SARGENT'S WHARF

Commentary

ALTERNATIVE C

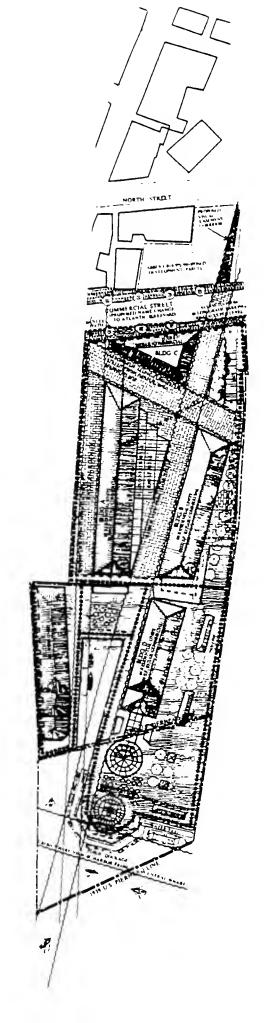
The above verbally described development for Sargent's Wharf is depicted, graphically in Alternative C and requires that Sargent's Wharf be extended beyond its current granite solid fill bulkhead, seaward, both to the older 1880 Pierhead line, and out still further to the 1939 U.S. Pierhead Bulkhead line.

The pier extension recommendation included in Alternative C probably will engender some criticism and debate, but I hope that after the idea is carefully considered, that it will be adopted. It is sometimes for-

75' (to peak of roof). (Proposed revision to IPOD requirement of 55' height limit for all structures within

MAXIMUM DEVELOPMENT HEIGHT (Building A & B shown) Permitted Height 55'

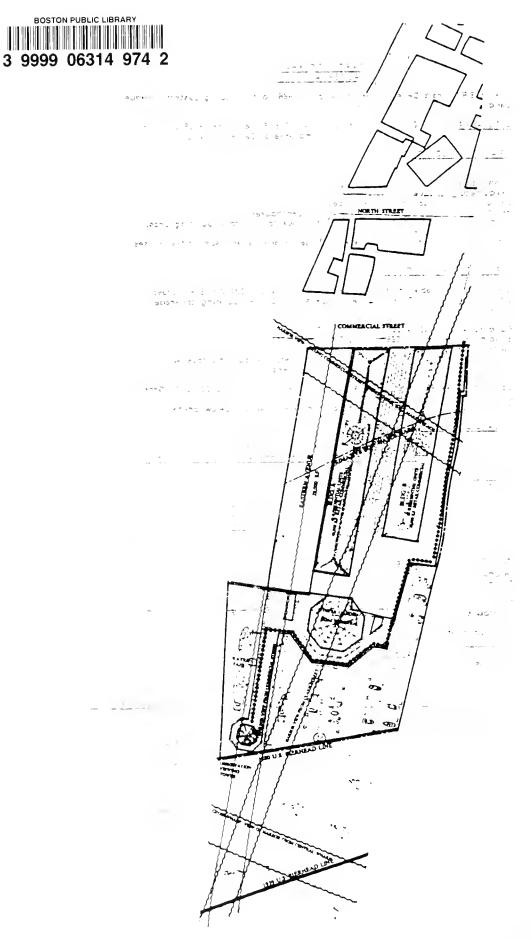
Due to the FAR limitation of two, permitting a building development area of 168,000 S.F., the proposed building cannot go to the SS' height limit permitted. Should the Gross Building Footprint Area be reduced to permit a 5th floor, this would not increase the amount of development area and, therefore, would have no effect on adding residential units.

If the commercial use requirement were reduced from 50% to 25%, this would allow an additional 42,000 S.F. to be devoted to residential, thereby adding 40 one and two-bedroom apartments.
